STAFF REPORT
COMMUNITY DEVELOPMENT DEPARTMENT

DATE: 9/28/2021
TO: City Council
FROM: Sonya Allen, Associate Planner
208-884-5533
SUBJECT: FP-2021-0046
Artemisia Subdivision

Request for final plat consisting of seven (7) building lots on 19.26 acres of land in the C-G zoning district for Artemisia Subdivision.

C. Landscape Plan (dated: 3/2/21)

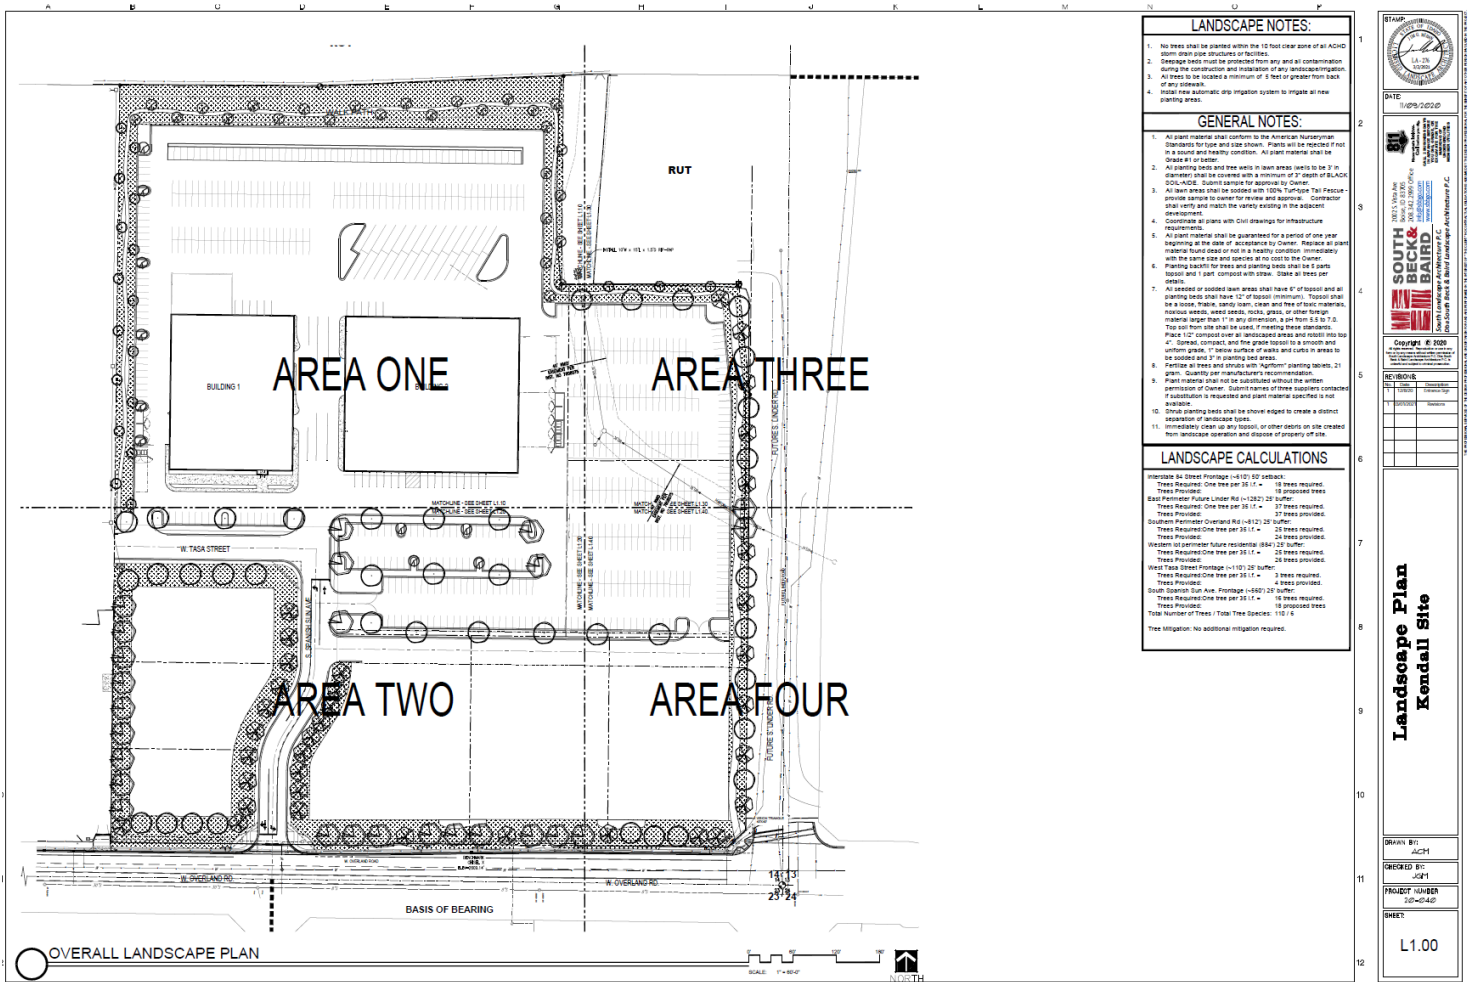
5. The landscape plan prepared by South Beck and Baird, dated 3/2/21 included in Exhibit C, shall be revised as follows:
 - a. Depict minimum 6-foot wide parkways/planting strips and detached minimum 5-foot wide sidewalks along all streets within the development per the Development Agreement. *The minimum width of parkways planted with Class II trees is 8-feet; the minimum width of parkway planters for Class I and III trees is 10-feet. Planter widths for Class II trees may be reduced to 6-feet if root barriers are installed per the standards listed in UDC 11-3A-17E.*

- b. Sidewalks/pathways shall include dedicated crosswalks at the intersection with all streets within commercial activity centers and shall be distinguished from surrounding paving per the Development Agreement.

- c. Change the fencing material around the Kendall Ford site to a higher quality than chain-link (i.e. wrought iron), per the Development Agreement.
 - d. Include one (1) additional tree in the southern perimeter street buffer along W. Overland Rd. to comply with UDC 11-3B-7C.3b.

- e. In the Landscape Calculations table, include calculations that demonstrate compliance with the standards for pathway (11-3B-12C) and parkway (11-3B-7C) landscaping; include required vs. provided number of trees.
